**NOTICE OF ADDENDUM  
ADDENDUM NO. 2**

**CONTRACT NO. 9086  
Metro Transit Hanson Rd Bus Facility Remodel**

This addendum is issued to modify, explain or correct the original Drawings, Specifications, or Contract Documents marked as ***Metro Transit Hanson Rd Bus Facility Remodel, City of Madison Project 10950, Contract No. 9086, as issued on September 19, 2023, Addendum #1 as issued on September 28, 2023 and Addendum #2 as issued on October 17, 2023.*** The addenda are hereby made a part of the contract documents, represents clarifications of the previously released documents, consists of eleven (11) pages, and the referenced exhibits.

**OVERALL SITE PLAN**

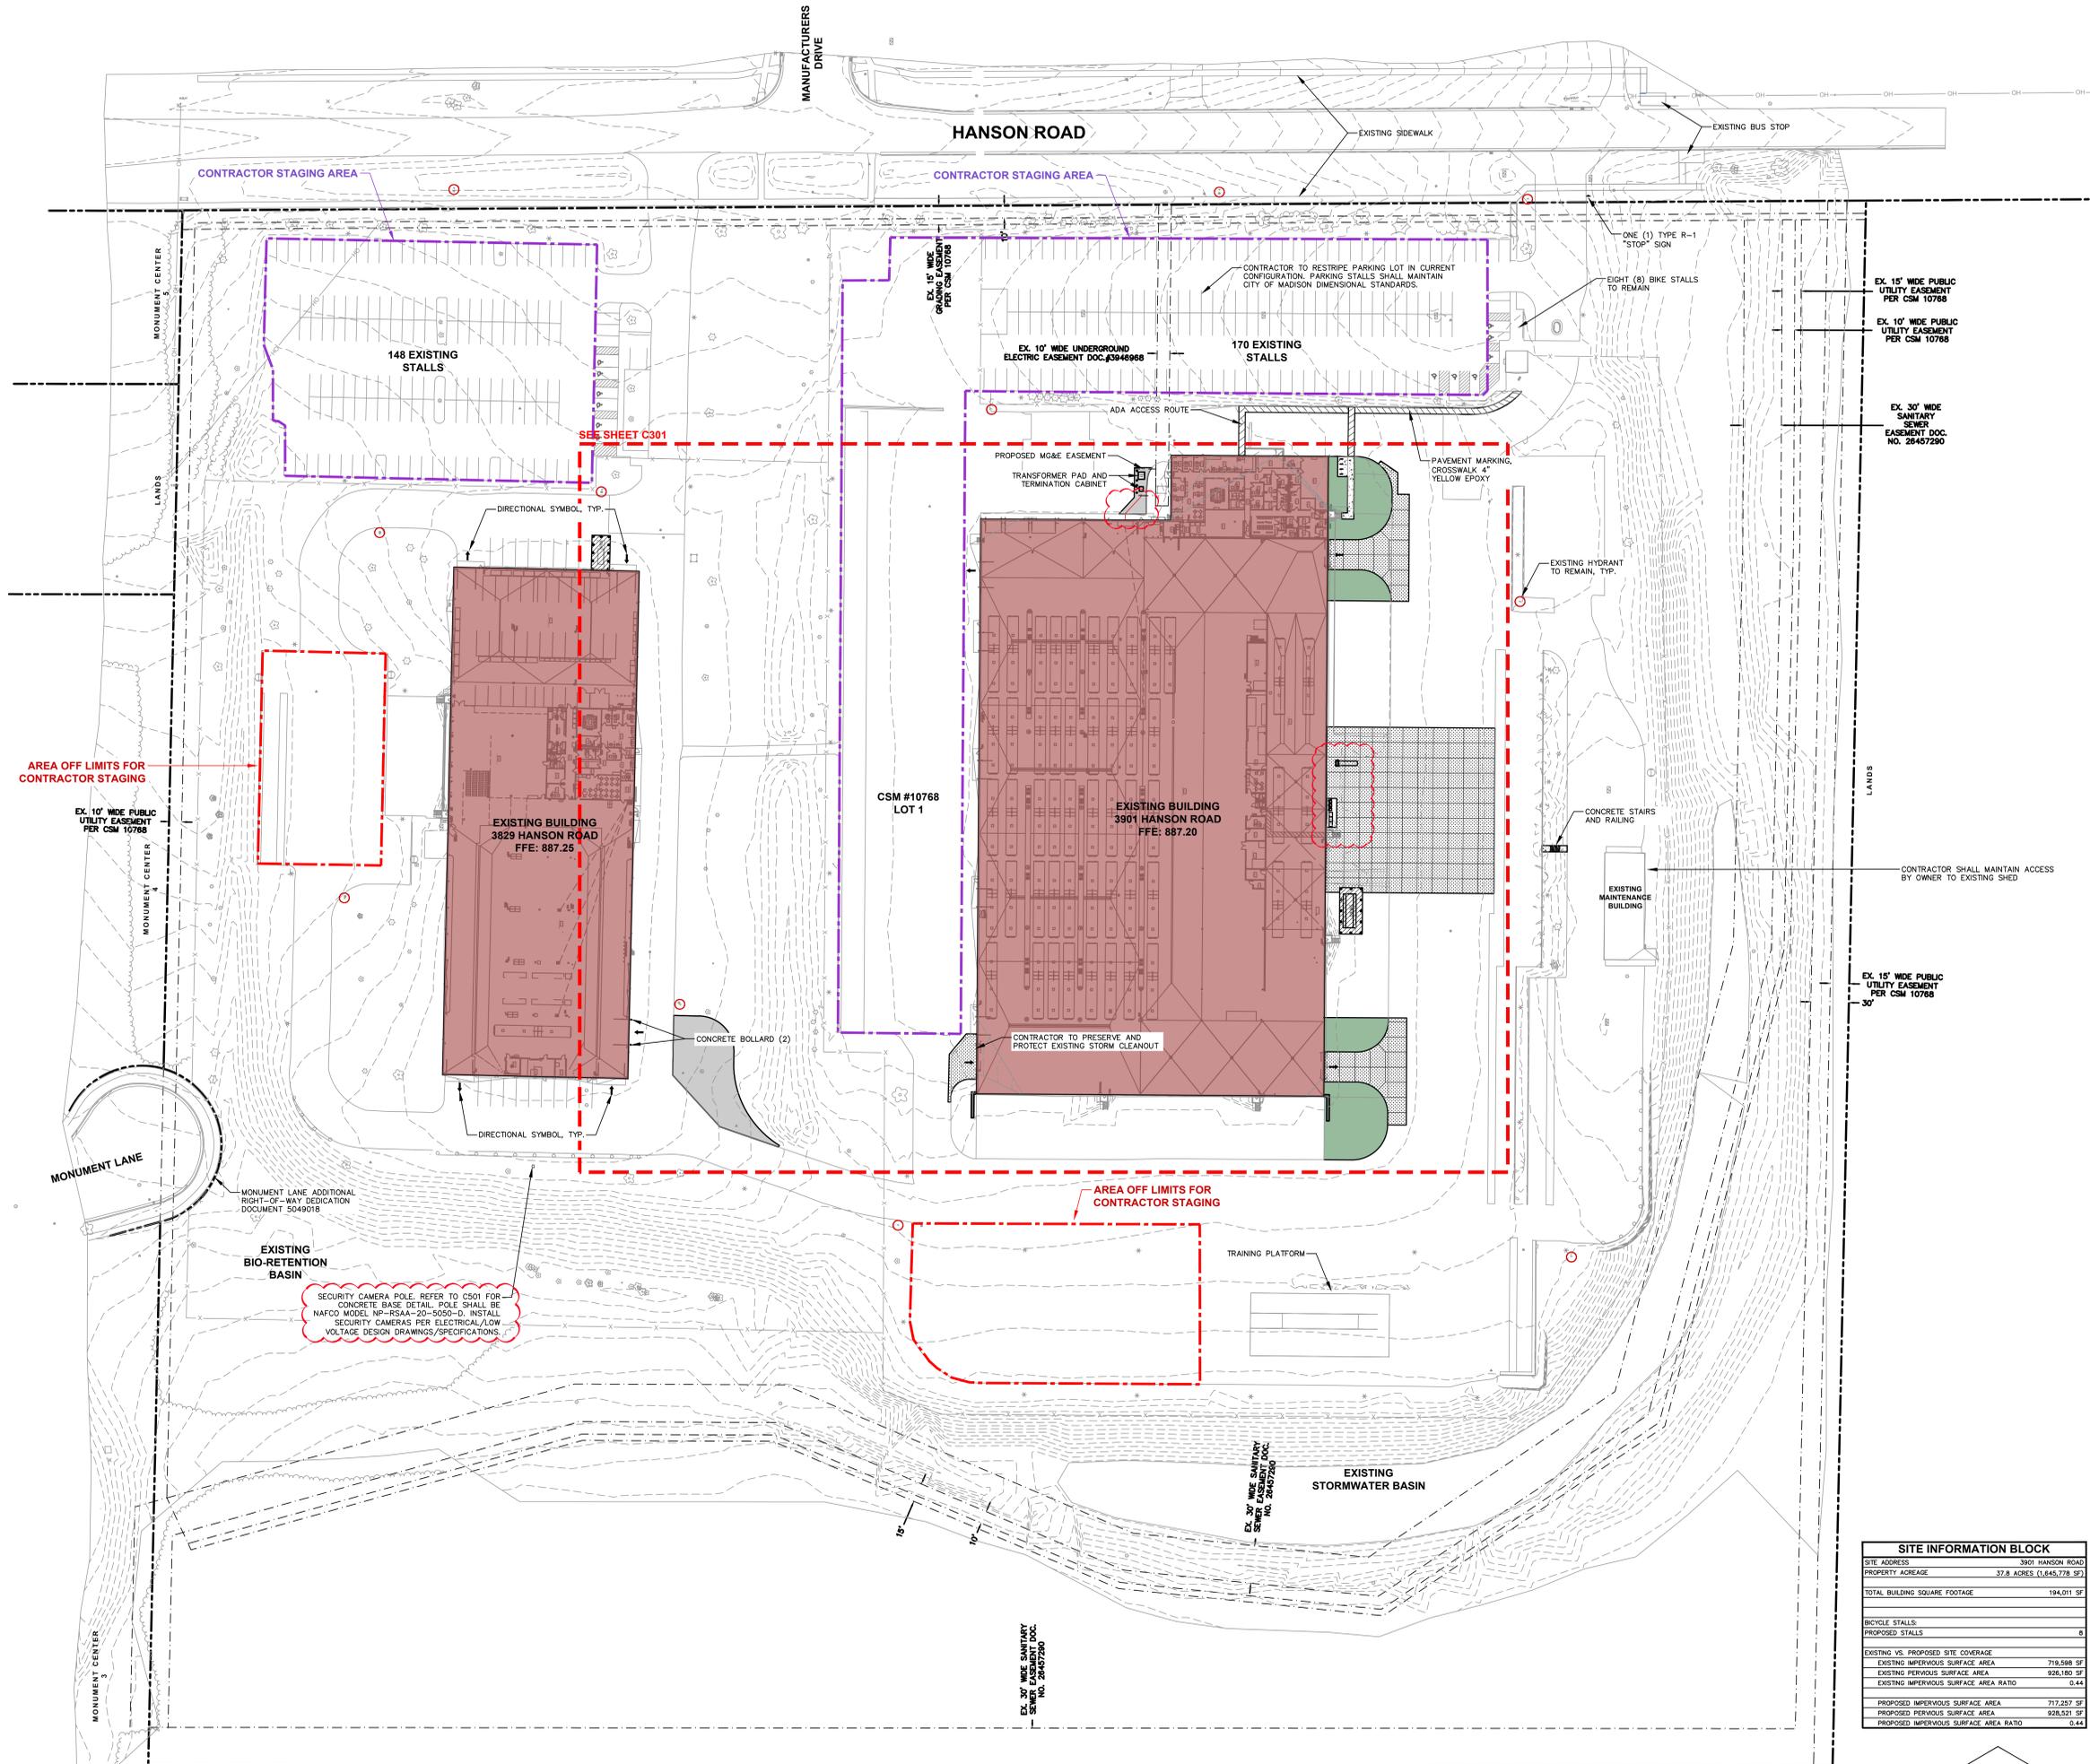
2. C300 Overall Site Plan
  - A. Revise pavement area around proposed transformer location.
  - B. Revise callout for proposed camera pole.
  - C. Revise bus charger station location and layout.

1 MAINTENANCE BUILDING - EAST ELEVATION DEMOLITION  
SCALE: 1/16" = 1'-0"

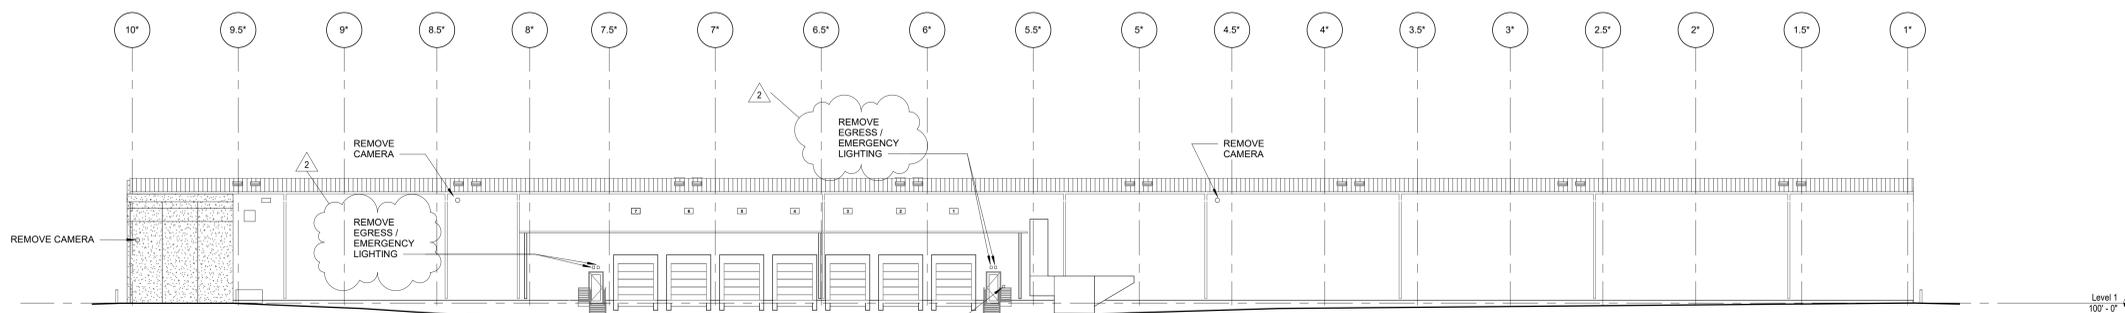
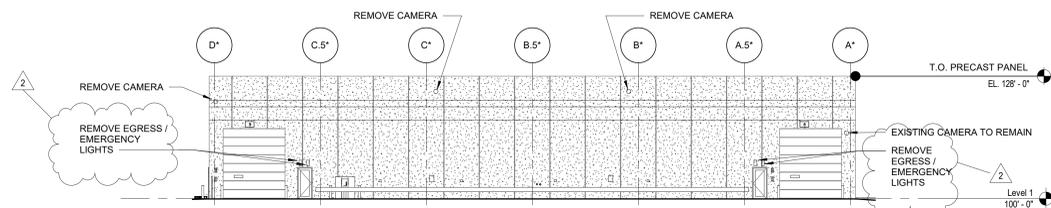
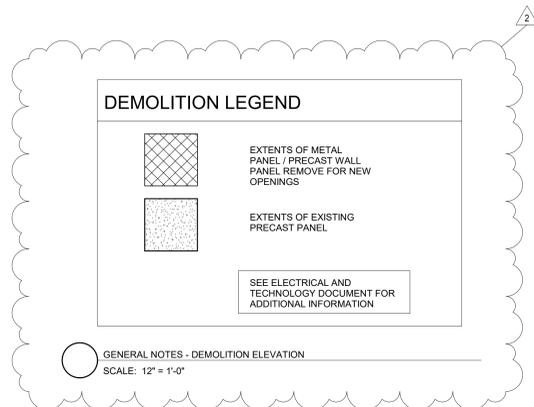
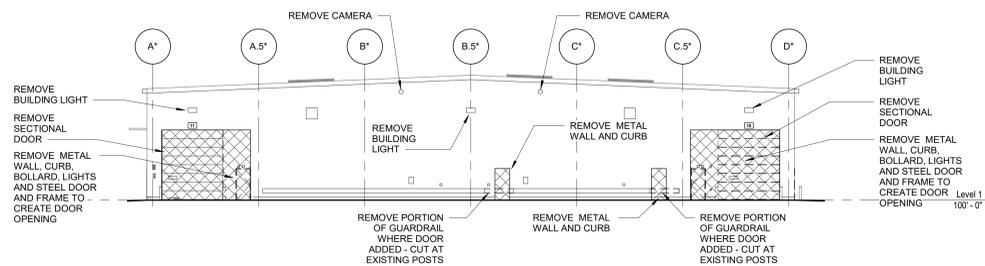
7. Sheet D400 is not clear in elevations 1 thru 3 what area of the pre-cast wall panels get removed for install of new overhead doors. Please confirm what the hatching specifically at these elevations on the sheet denote as there does not appear to be a sheet legend.

6. D400 Demolition Elevations - Maintenance Building
  - A. Detail 1 – East elevation
    1. Revise note regarding removal of egress / emergency lighting.

2. Add metal wall panel removal for door opening.
  - B. Detail 2 – West elevation
    1. Revise note regarding removal of egress / emergency lighting.

- C. Detail 3 – North elevation
    1. Revise note regarding removal of egress / emergency lighting.
  - D. Detail 4 – South elevation
    1. Revise note regarding removal of egress / emergency lighting.

- a. Refer to the revised elevations contained within the addendum.
8. Please confirm as it is not depicted on Sheet A400 or A401, if the existing accent color bands on the buildings are to be re-painted.

1 STORAGE BUILDING - EAST ELEVATION DEMOLITION  
SCALE: 1/16" = 1'-0"

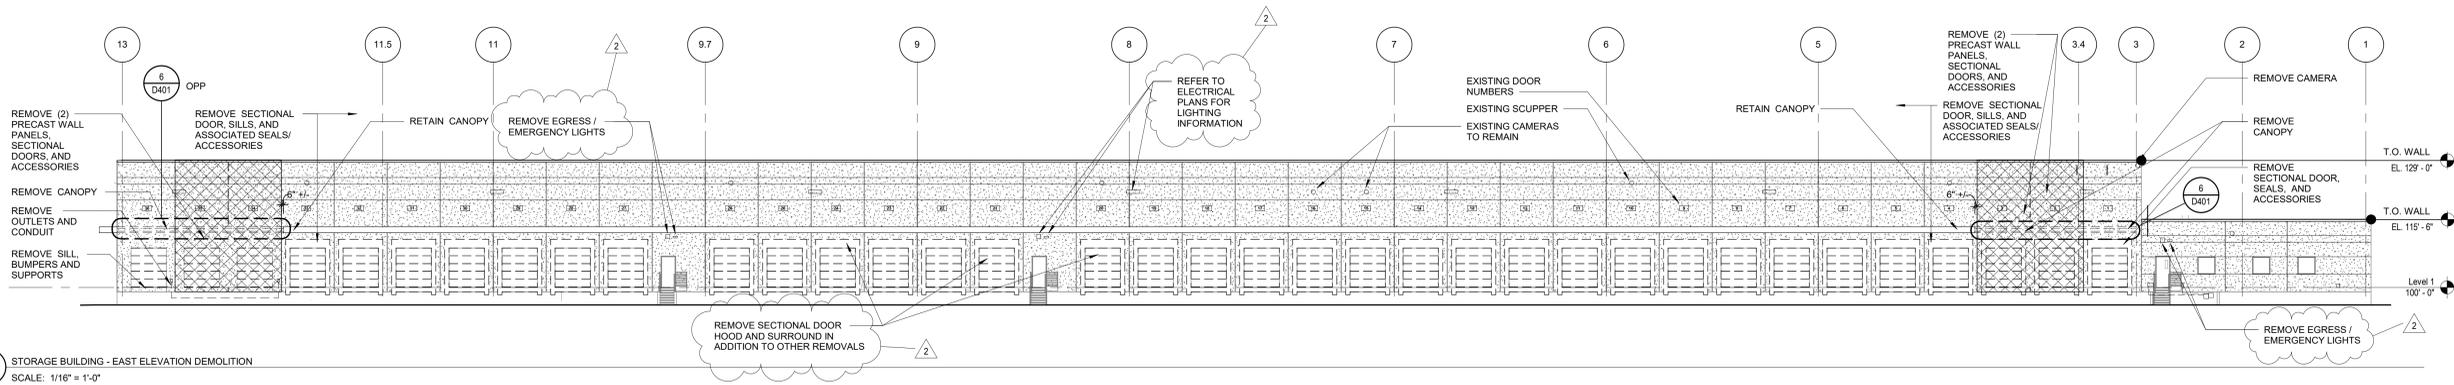
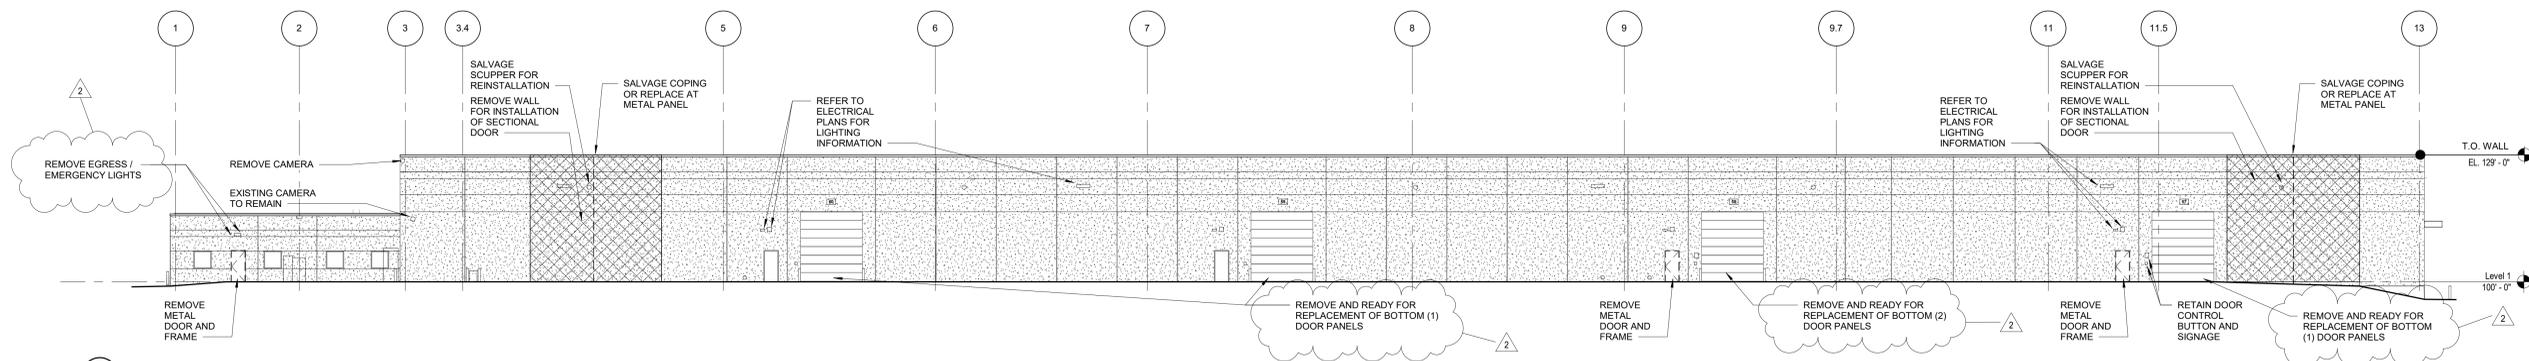
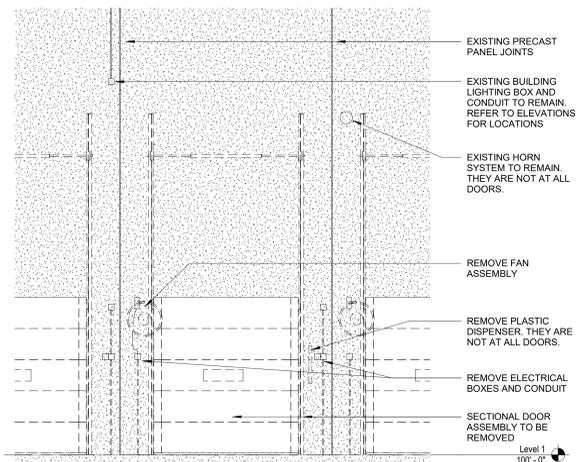
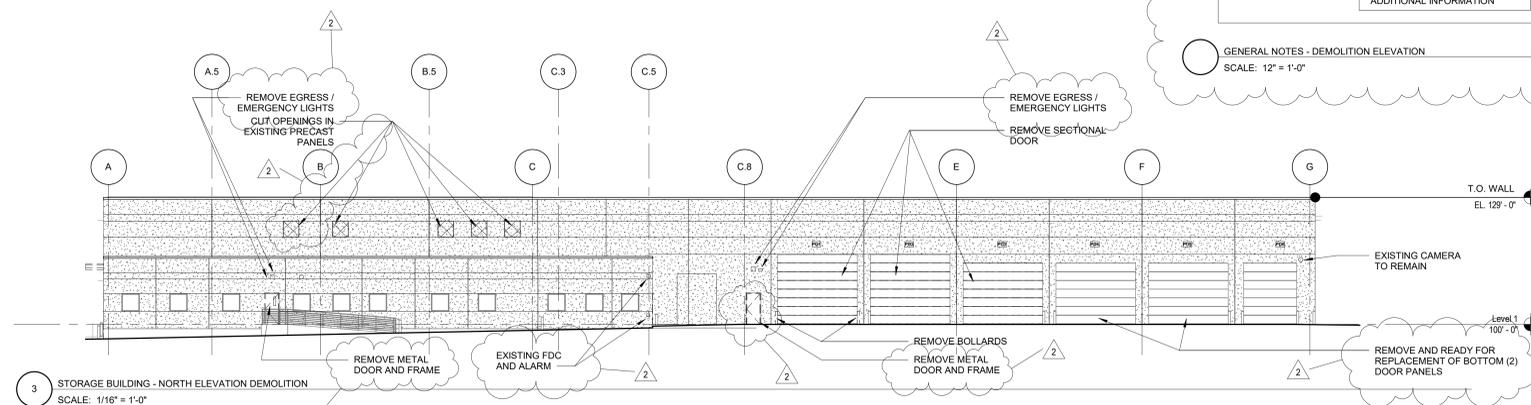
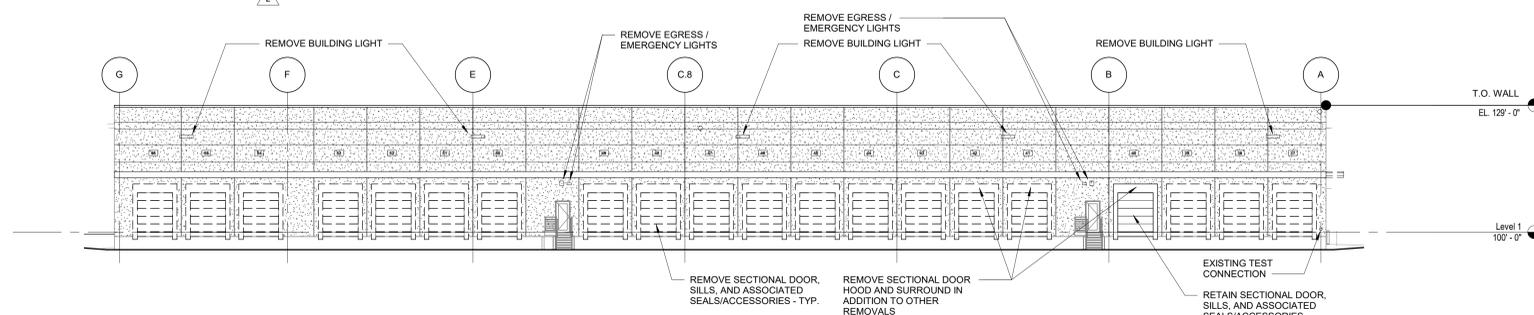
- E. Demolition Legend
    1. Add Legend
7. D401 Demolition Elevations - Storage Building
  - A. Detail 1 – East elevation
    1. Add notes regarding removal of egress / emergency lighting.

2. Add note regarding removal of sectional door hood and surround.
  - B. Detail 2 – West elevation
    1. Revise note regarding removal of egress / emergency lighting.

2. Add notes regarding sectional door panel replacement.
  - C. Detail 3 – North elevation
    1. Revise note regarding removal of egress / emergency lighting.

6. Add note regarding metal door and frame removal.
  - D. Detail 5 – South elevation
    1. Add notes regarding removal of egress / emergency lighting.
